JAMES A. FITZPATRICK NUCLEAR POWER PLANT

AMENDMENT TO FACILITY OPERATING LICENSE

Amendment No. 105  
License No. DPR-59

SAFETY EVALUATION BY THE OFFICE OF NUCLEAR REACTOR REGULATION  
SUPPORTING AMENDMENT NO. 105 TO FACILITY OPERATING LICENSE NO. DPR-59  
POWER AUTHORITY OF THE STATE OF NEW YORK  
JAMES A. FITZPATRICK NUCLEAR POWER PLANT  
DOCKET NO. 50-333

**FIGURE 6.1-1**  
**MANAGEMENT ORGANIZATION CHART**  
**POWER AUTHORITY OF THE STATE OF NEW YORK**  
**JAMES A. FITZPATRICK NUCLEAR POWER PLANT**

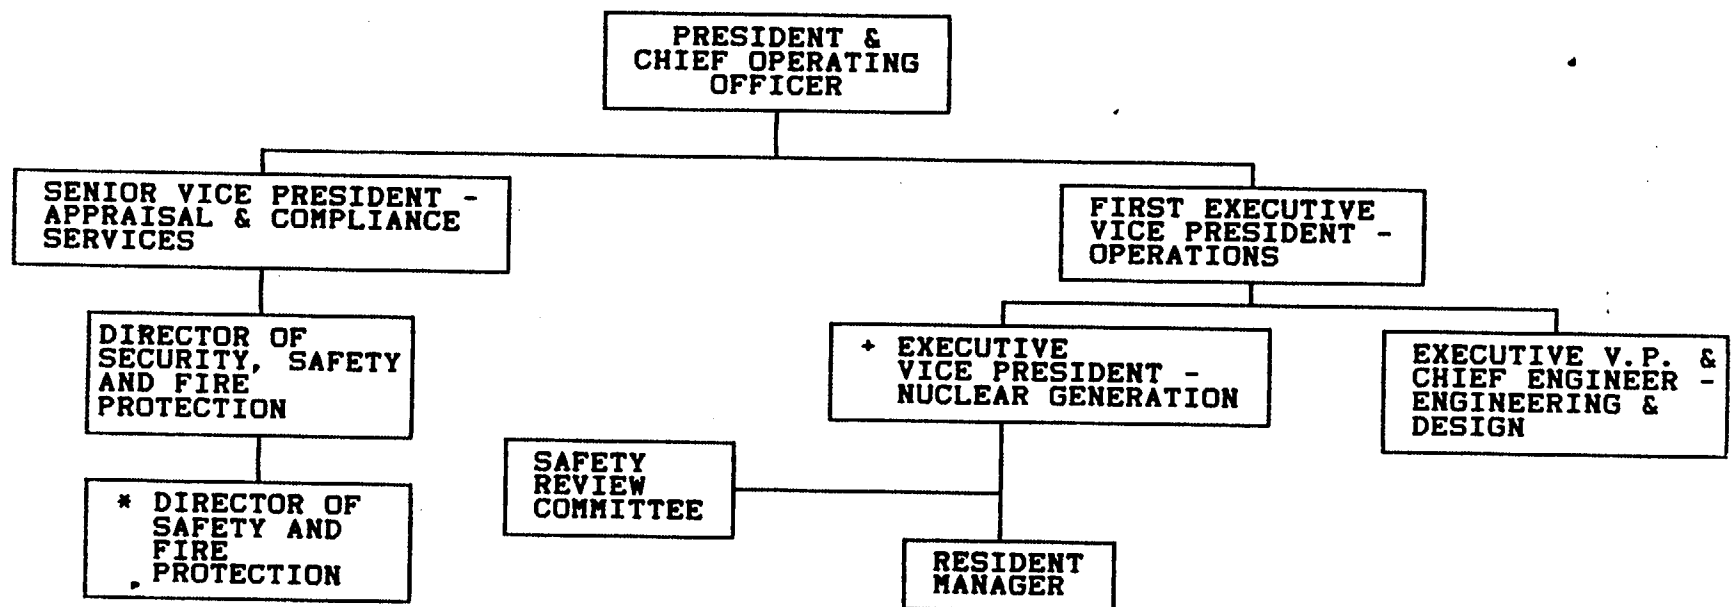
2.1 Proposed Change to Figure 6.1-1

The licensee proposed the following changes to Figure 6.1-1 of the FitzPatrick TS.

- ° The Department of Quality Assurance and Reliability has been changed to the Department of Appraisal and Compliance Services. In addition, the title of the Vice President of Quality Assurance and Reliability has been changed to Senior Vice President - Appraisal and Compliance Services. The Department of Appraisal and Compliance Services will retain all functions of the former Department except for the functions of Reliability Services. These functions have now been assigned to the Department of Engineering and Design. It is appropriate that Reliability Services report through engineering since engineering and purchase standards are set in this area.

- ° The Director of Safety and Fire Protection who previously reported to the Vice President - Quality Assurance and Reliability, now reports to the new position of Director of Security, Safety and Fire Protection. The only change for the Director of the Safety and Fire Protection is in reporting responsibility. He now reports to the new position of Director of Security, Safety and Fire Protection.

- ° The Executive Vice President and Chief Engineer - Engineering and Design now reports to the First Executive Vice President - Operations. The position of First Executive Vice President and Chief Development Officer has been eliminated. Staff support engineering is consolidated under the Executive Vice President and Chief Engineer - Engineering and Design. This permits optimal use of department resources. Realigning the reporting responsibility of this position to the First Executive Vice President-Operations relieves the Engineering Department of direct construction responsibility. This responsibility is now under the Project Management Department. Design, operations and construction are now under the First Executive Vice President - Operations, including all demands for resources for operating plans and new construction projects.

The staff finds that the above proposed changes including these new reporting relationships should improve managerial control and provide better management efficiency. The reorganization should provide clear effective lines of authority. Therefore, we find these changes acceptable, since they meet the criteria specified in Section 13.1.1 and 13.1.2 of the Standard Review Plan (SRP).

FIGURE 6.2-1

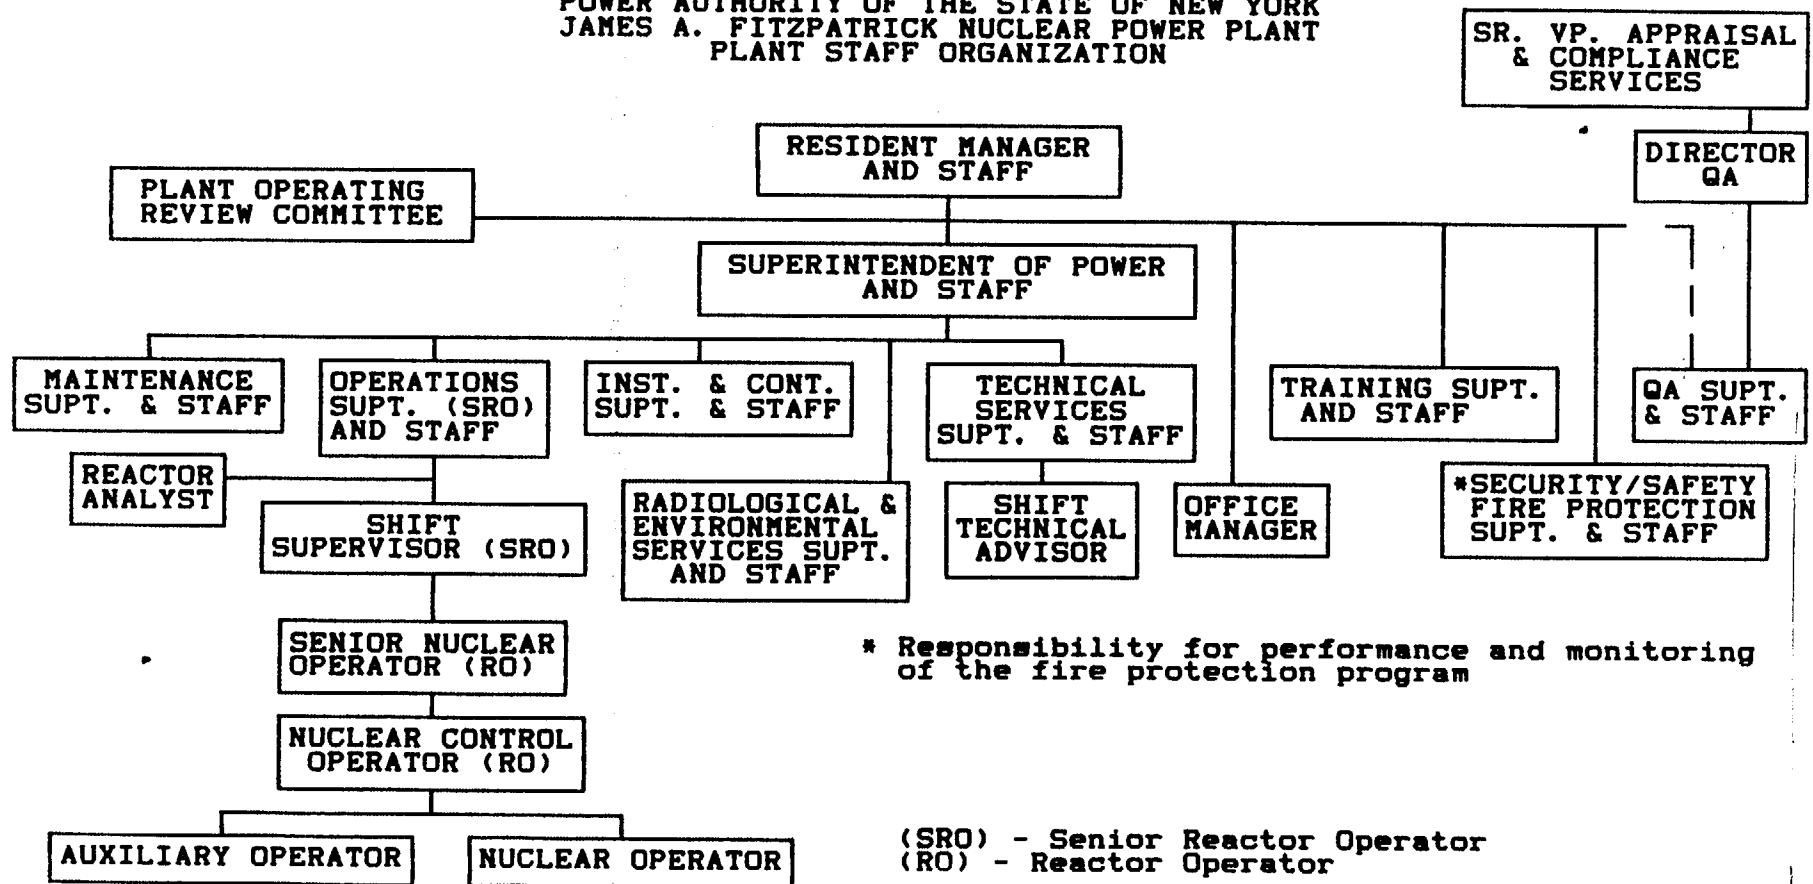
## 2.2 Proposed Change to Figure 6.2-1

The proposed changes to Figure 6.2-1 reflect the change in title of the Senior Vice President - Quality Assurance and Reliability. In addition, a new position has been added. The Director - Quality Assurance will report to the Senior Vice President - Appraisal and Compliance Services. Consequently, the Quality Assurance Superintendent and staff will now report to the Director - Quality Assurance.

The Director - Quality Assurance has the day-to-day responsibility and authority for the development, implementation and maintenance of the Quality Assurance Program. The Director - Quality Assurance will provide for a closer monitoring of safety related activities and will report to affected department heads concerning Quality Assurance Program requirements.

The staff finds that the above proposed change will better focus management attention on the performance of activities related to safe operation. In particular, we feel the change will increase the involvement of the Quality Assurance organization. Therefore, we find this proposed change acceptable.
